CALL NO. 106
CONTRACT ID NO. 224416
ADDENDUM # 1

Subject: Barren County, HSIP 9010 (332)
Letting March 24, 2022

- (1) Revised - Special Notes - Pages 21 & 59 of 100
- (2) Added - Detail Sheets - Pages 67(a)-67(b) of 100

TYPICAL SECTION FOR DITCHING AND SHOULDERING

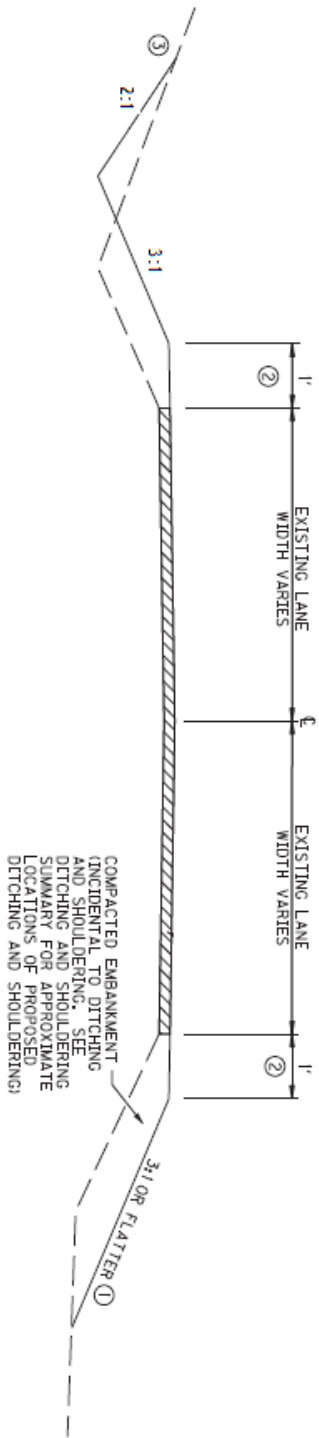
Provide positive drainage of ditches and slopes at all times during and upon completion of construction. When asphalt surfacing or resurfacing is included in the contract, perform all ditching and as much of the shouldering operations as is practical before beginning final surfacing operations.

F. Embankment Benching. Embankment Benching shall be required when the existing groundline has an incline greater than 15%. Any and all required embankment benching shall be incidental to the bid item DITCHING & SHOULDERING. For more information refer to the DITCHING & SHOULDERING AND EMBANKMENT BENCHING DETAILS.

- NOTES:
- CONTRACTOR SHALL PROPERLY BENCH INTO EXISTING SLOPE AND APPLY PROPER COMPACTION.
 - COMPACT MATERIAL ACCORDING TO STANDARD SPECIFICATIONS (SECT. 206).

- FINAL PAYMENT WILL BE PAID AS LE OF DITCHING AND SHOULDERING AND INCLUDE ALL WORK NECESSARY TO PERFORM WORK.
 - SHOULDER EMBANKMENT MATERIAL SHALL BE SUITABLE FOR VEGETATION GROWTH.

- DITCH DEPTH AND SLOPE WILL VARY DEPENDING ON EXISTING CONDITIONS. PROPOSED DITCH SHALL HAVE 1 FT DEPTH MINIMUM.
- ① 3:1 OR FLATTER IS DESIRABLE. LOCATIONS THAT ARE LIMITED DUE TO RIGHT-OF-WAY, UTILITY POLES, TREES, FENCES, OR OTHER SENSITIVE OBSTRUCTIONS MAY REQUIRE EMBANKMENT BUT ONLY OUT TO THE EDGE OF THE RIGHT-OF-WAY OR SENSITIVE OBSTRUCTIONS. (SLOPE MAY BE STEEPER THAN 3:1)

- ② A 1' SHOULDER IS DESIRABLE BUT MAY HAVE TO BE ELIMINATED IN ORDER TO REMAIN ON RIGHT-OF-WAY OR AVOID A SENSITIVE OBSTRUCTION.
- ③ FLATTEN DITCH BACKSLOPE WHEN POSSIBLE TO REMAIN IN RIGHT-OF-WAY. IN AREAS WHERE THE BACKSLOPE MUST REMAIN STEEP, THE ENGINEER MAY DETERMINE THAT CHANNEL LINING NEEDS TO BE INSTALLED TO HELP STABILIZE THE BACKSLOPE.

FIGURE 1

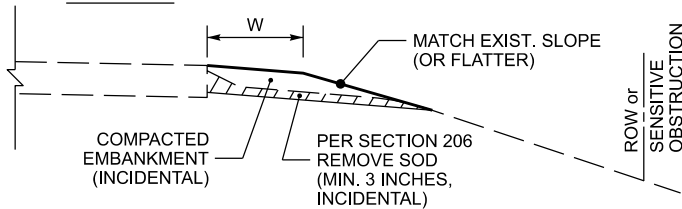
3. AS SHOWN IN FIGURE 1, IN SOME SITUATIONS, MINOR SHOULDERING, WITH MINIMAL ADDITIONAL EARTH MATERIAL, MAY BE ALL THAT IS REQUIRED TO RESHAPE THE EARTH SHOULDER TO THE PROPOSED WIDTH AND BRING IT FLUSH WITH THE EDGE OF PAVEMENT.

FIGURE 2

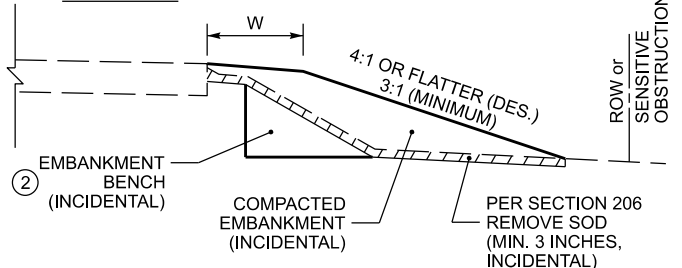
4. AS SHOWN IN FIGURE 2, MOST SITUATIONS WILL REQUIRE ADDITIONAL EARTH MATERIAL TO ACHIEVE THE PROPOSED EARTH SHOULDER WIDTH. IT IS DESIRED THAT THE RESULTING FILL SLOPE BE INSTALLED AS FLAT AS POSSIBLE AND REMAIN WITHIN THE RIGHT-OF-WAY AND/OR AVOID SENSITIVE OBSTRUCTIONS.

FIGURE 3

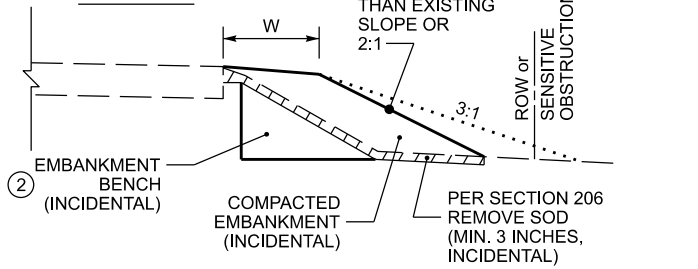
5. AS SHOWN IN FIGURE 3, IF A 3:1 FILL SLOPE WILL RESULT IN THE TOE OF SLOPE EXTENDING BEYOND THE RIGHT-OF-WAY OR IMPACT A SENSITIVE OBSTRUCTION, THEN THE FILL SLOPE MAY BE INSTALLED STEEPER THAN 3:1, BUT NO STEEPER THAN THE EXISTING FILL SLOPE, OR A 2:1, WHICHEVER IS FLATTER.

FIGURE 4

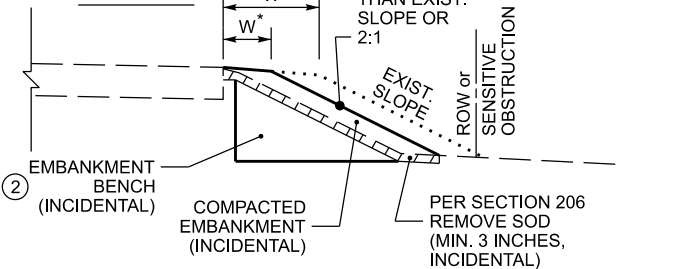
6. AS SHOWN IN FIGURE 4, IF MATCHING THE EXISTING FILL SLOPE OR INSTALLING A 2:1 FILL SLOPE (WHICHEVER IS FLATTER) STILL RESULTS IN THE TOE OF SLOPE EXTENDING BEYOND THE RIGHT-OF-WAY OR STILL IMPACTS A SENSITIVE OBSTRUCTION, THEN THE PROPOSED EARTH SHOULDER WIDTH MAY BE REDUCED SO THAT THE RESULTING TOE OF SLOPE WILL REMAIN WITHIN THE RIGHT-OF-WAY AND/OR NOT IMPACT THE SENSITIVE OBSTRUCTION.

FIGURE 5

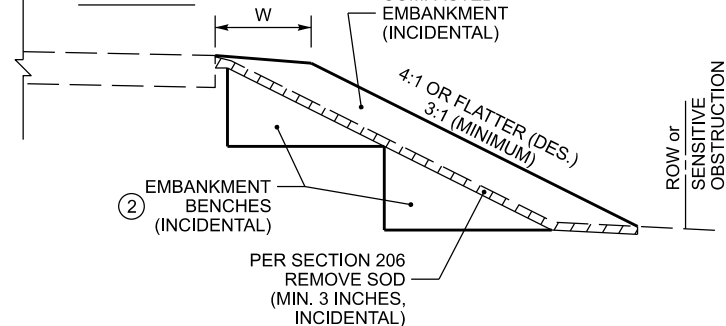
7. AS SHOWN IN FIGURE 5, AS THE HEIGHT OF THE FILL INCREASES, MULTIPLE EMBANKMENT BENCHES MAY BE REQUIRED.

FIGURE 7

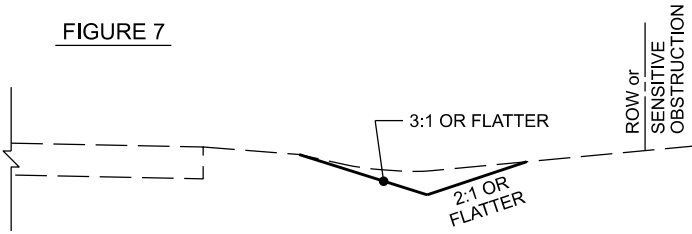
8. AS SHOWN IN FIGURE 7, IN SOME SITUATIONS, ALL THAT MAY BE REQUIRED IS TO CLEAN OUT THE EXISTING DITCH AND RESHAPE IT TO THE PROPOSED DIMENSIONS. THE MATERIAL EXCAVATED FROM THE DITCH MAY BE RE-USED ELSEWHERE ON THE PROJECT, PROVIDED THE ENGINEER DETERMINES THE MATERIAL REMOVED FROM THE DITCH IS SUITABLE FOR THE INTENDED RE-USE.

FIGURE 8

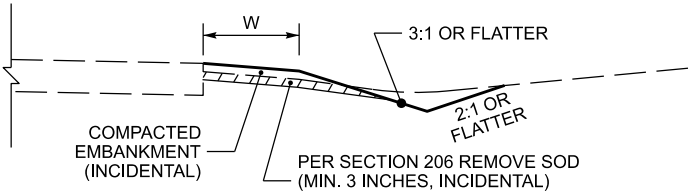
9. AS SHOWN IN FIGURE 8, IN SOME SITUATIONS, THE DITCH AND SHOULDER MAY ONLY NEED MINOR REGRADING AND/OR RESHAPING. THE MATERIAL EXCAVATED FROM THE DITCH MAY BE USED TO RESHAPE THE EARTH SHOULDER, PROVIDED THE ENGINEER DETERMINES THE MATERIAL REMOVED FROM THE DITCH IS SUITABLE FOR SHOULDERING. IF THE MATERIAL IS NOT SUITABLE, ADDITIONAL EARTH MATERIAL MAY BE REQUIRED.

FIGURE 9

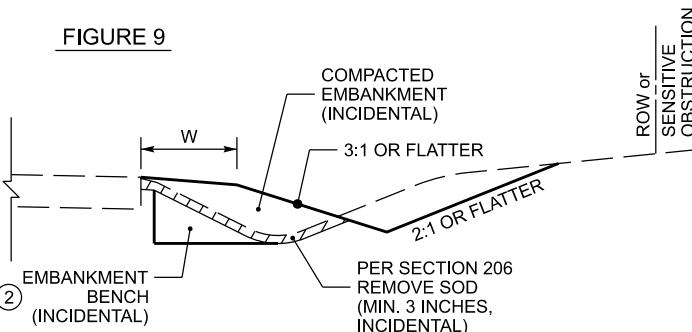
10. AS SHOWN IN FIGURE 9, IN MOST SITUATIONS, REGRADING AND RESHAPING THE ROADSIDE TO ACHIEVE THE PROPOSED SHOULDER, DITCH, AND/OR ROADSIDE DIMENSIONS WILL RESULT IN MOVING THE DITCH FURTHER AWAY FROM THE ROADWAY. IT IS DESIRED THAT DITCH FORESLOPES BE 3:1 OR FLATTER AND DITCH BACKSLOPES BE 2:1 OR FLATTER.

FIGURE 10

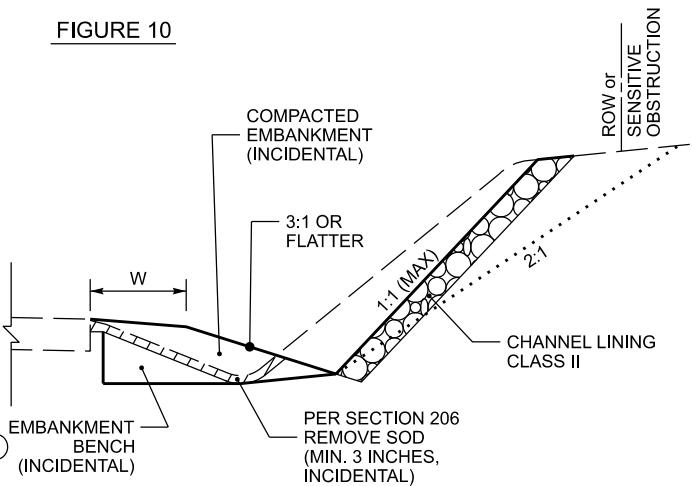
11. AS SHOWN IN FIGURE 10, IF INSTALLING A 2:1 DITCH BACKSLOPE WILL RESULT IN THE TOP OF CUT EXTENDING BEYOND THE RIGHT-OF-WAY OR IMPACTING A SENSITIVE OBSTRUCTION, THEN THE DITCH BACK SLOPE MAY BE INSTALLED STEEPER THAN 2:1, UP TO 1:1 MAXIMUM. IN THIS SITUATION, THE DITCH BACKSLOPE SHALL HAVE CLASS II CHANNEL LINING INSTALLED FOR SLOPE PROTECTION.

FIGURE 11

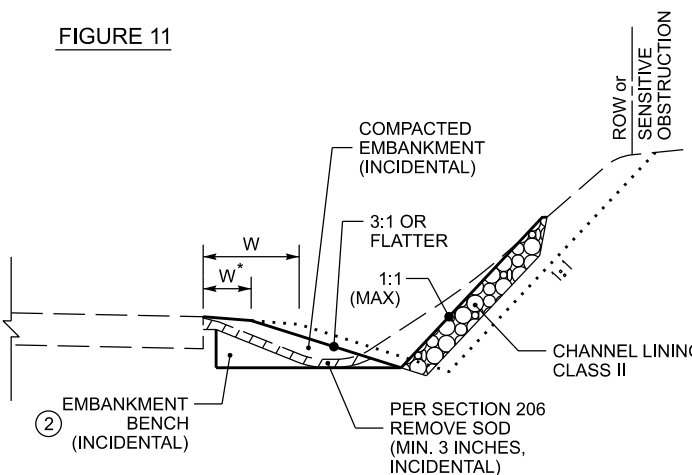
12. AS SHOWN IN FIGURE 11, IF USING A 1:1 DITCH BACKSLOPE STILL RESULTS IN THE TOP OF CUT EXTENDING BEYOND THE RIGHT-OF-WAY OR STILL IMPACTS A SENSITIVE OBSTRUCTION, THEN THE PROPOSED EARTH SHOULDER WIDTH MAY BE REDUCED SO THAT THE STEEP DITCH BACKSLOPE CAN BE INSTALLED WITHIN THE RIGHT-OF-WAY AND/OR TO AVOID A SENSITIVE OBSTRUCTION.
